HISTORIC AND DESIGN REVIEW COMMISSION

November 06, 2019

HDRC CASE NO: 2019-660
ADDRESS: 132 CAMARGO
LEGAL DESCRIPTION: NCB 923 BLK 4 LOT N 75FT OF E 27.8FT OF 6 & N 75FT OF 7
ZONING: RM-4,H
CITY COUNCIL DIST.: 1
DISTRICT: Lavaca Historic District
APPLICANT: Robert Alvarado
OWNER: Beanville Bungalows
TYPE OF WORK: Relocation of primary structure within lot, exterior modifications
APPLICATION RECEIVED: October 10, 2019
60-DAY REVIEW: December 09, 2019
CASE MANAGER: Stephanie Phillips
REQUEST:

1. Relocate the primary structure addressed 132 Camargo approximately 12 feet east of its current location within the same lot.
2. Install salvaged wood windows and doors in the existing openings on the reconstructed structure.
3. Install a new concrete driveway to the east of the relocated structure.

126, 130, & 132 CAMARGO - PROPOSED SITE PLAN

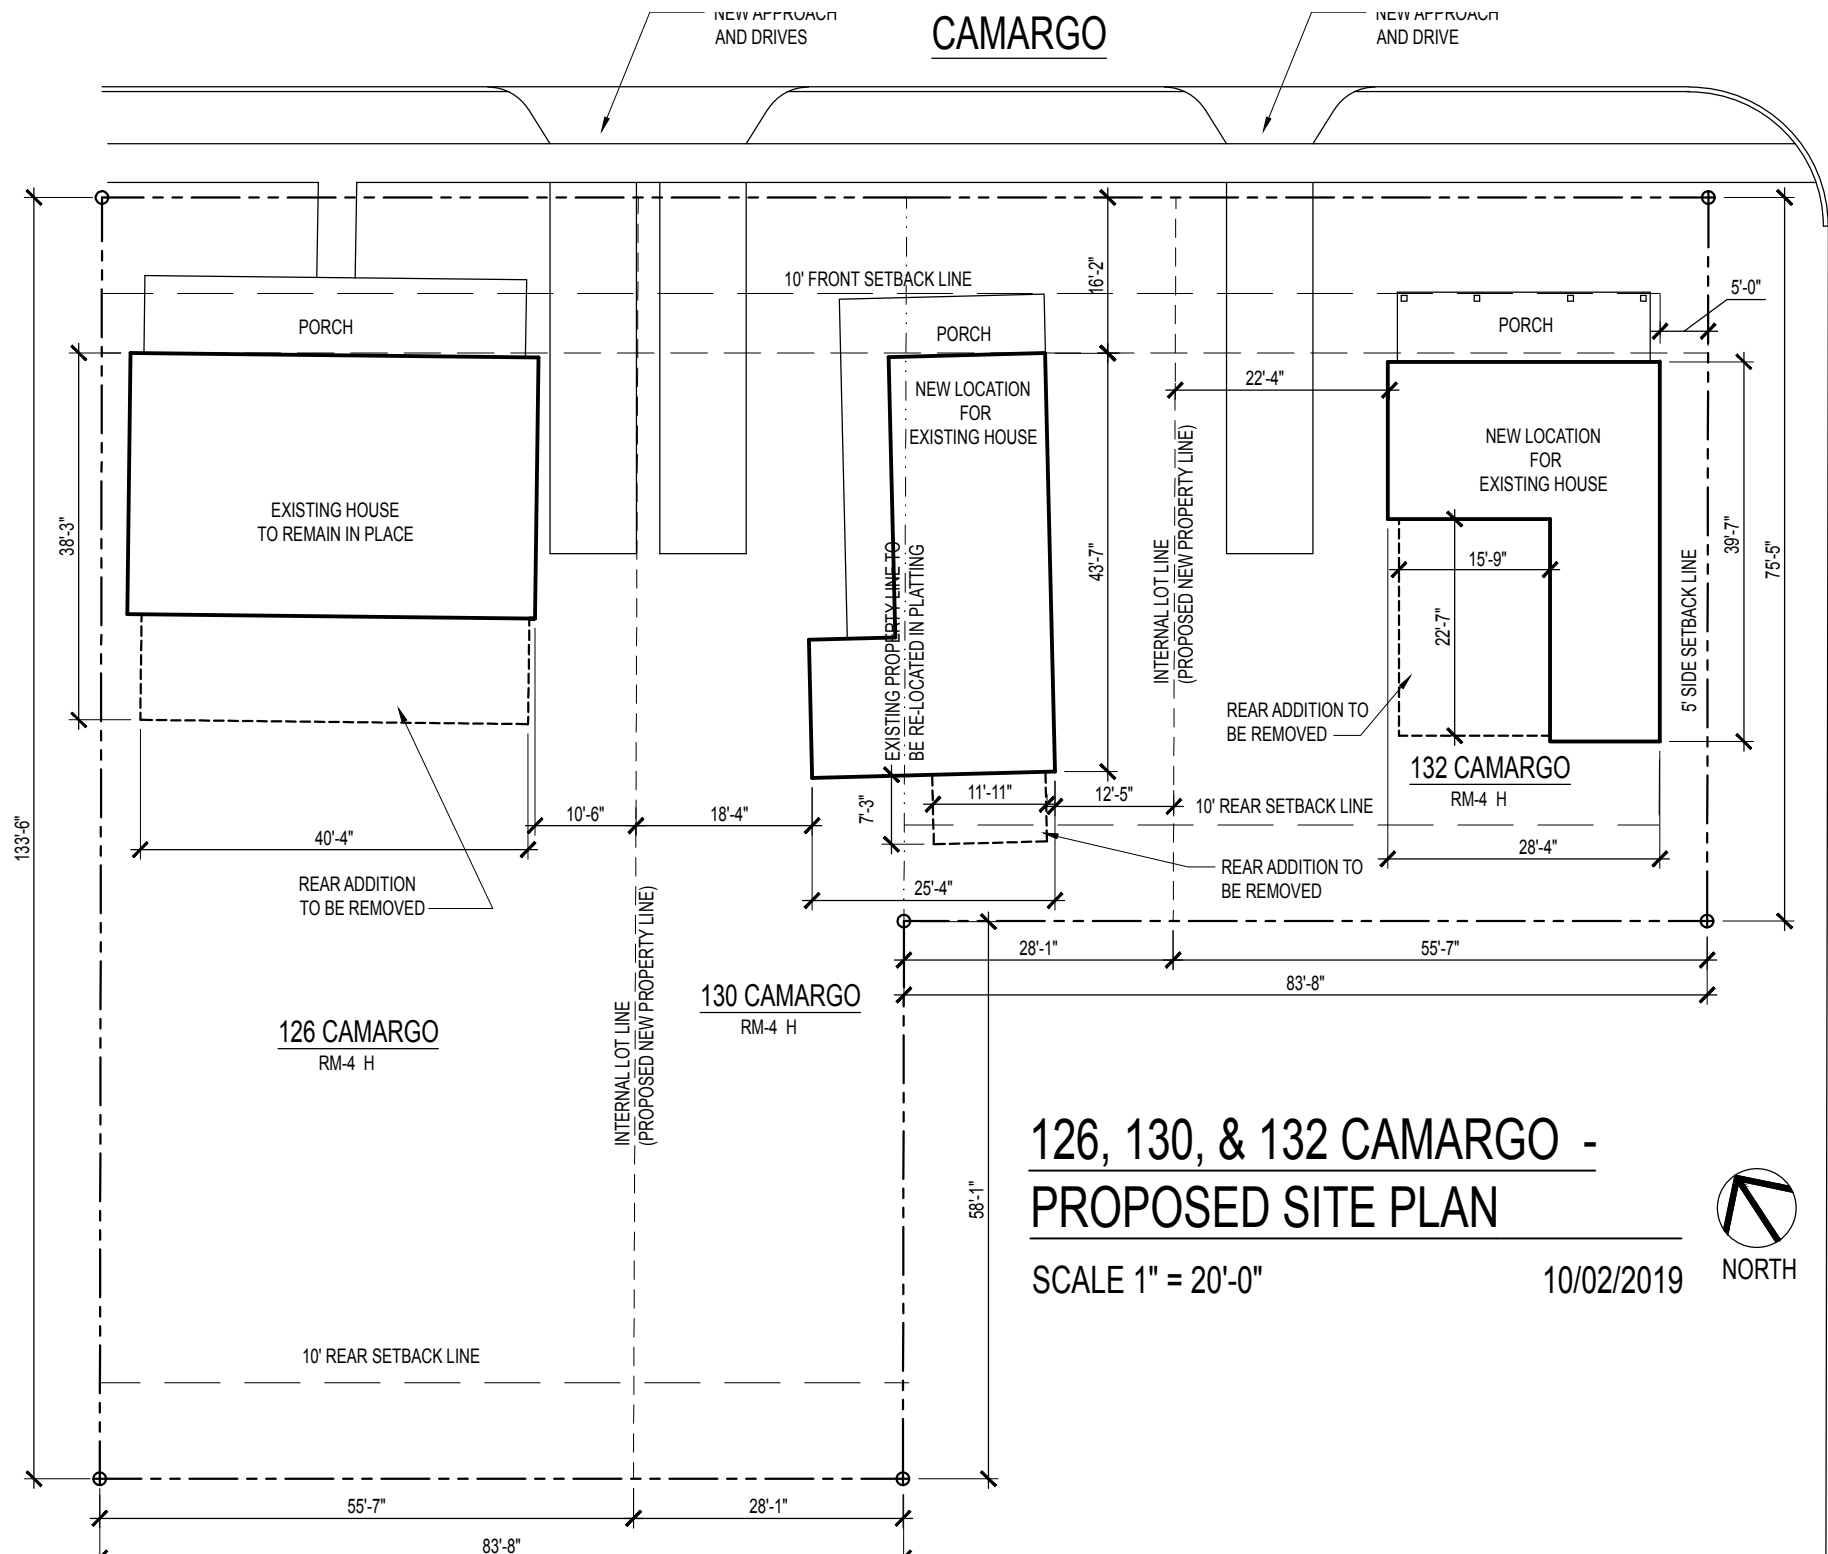
- c. RELOCATION – The applicant has proposed to relocate the structure approximately 12 feet to the east on the same lot. The new location will be 5 feet from the east property line along San Arturo and will position the structure as a corner lot residence. The lot, along with lots addressed 130 and 126 Camargo, will be replatted to adjust the property lines and three create single family lots. Staff generally finds fully intact relocation to be appropriate based on the historic development pattern of the district. The removal of the non-original additions prior to relocation is eligible for administrative approval.

- e. DRIVEWAY AND CURB CUT – The applicant has proposed to install a new concrete driveway to the west of the relocated structure. The applicant has not indicated a proposed width. Staff generally finds the proposal to be appropriate with the stipulation that the driveway be no wider than 10 feet to comply with the Historic Design Guidelines for Site Elements.

- v. That the proposed concrete driveway is no wider than 10 feet and that the approach flares to no wider than 12 feet at its widest point as noted in finding e.
